MIL-T-60500A(MU)
AMENDMENT 4
15 March 1972
SUPERSEDING
AMENDMENT 3
15 December 1971

MILITARY SPECIFICATION

TRANSCEIVER: 10540501

This amendment forms a part of Military Specification MIL-T-60500A(MU), dated 22 September 1970.

FIGURE 3

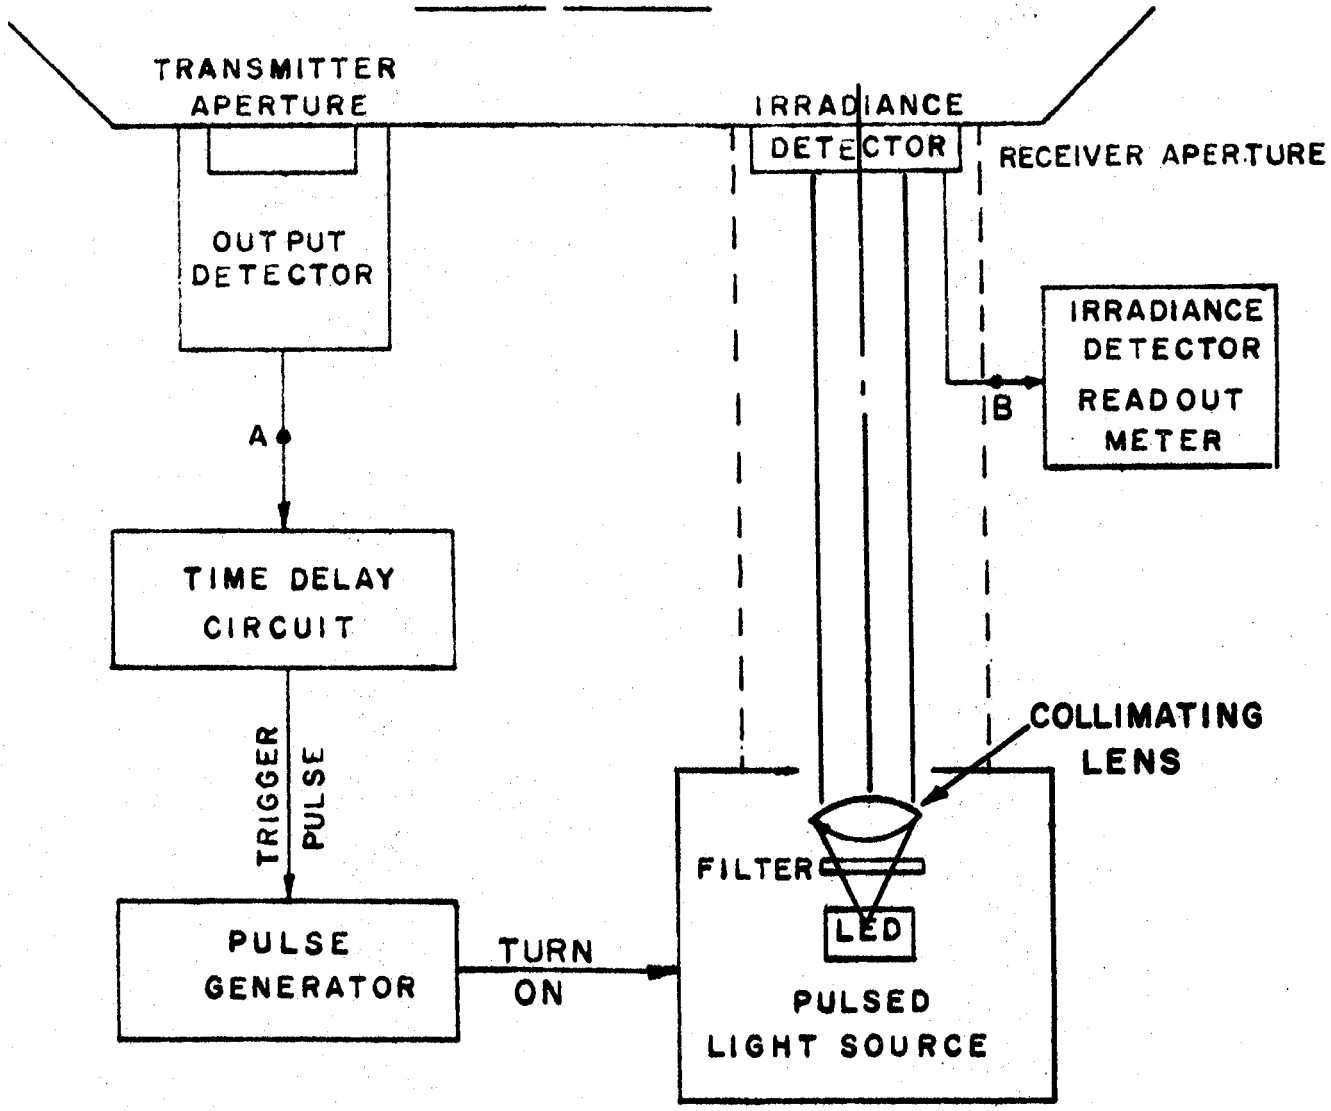
Figure 3: Delete and substitute attached Figure 3.

NOTE: 1. MEASURE TIME DELAY FROM POINT "A" FROM OUTPUT DETECTOR TO POINT "B" FROM IRRADIANCE DETECTOR.

2. ISOLATE THE RECEIVER APERTURE TO PREVENT ERRONEOUS READINGS FROM REFLECTIONS FROM OUTPUT PULSE.
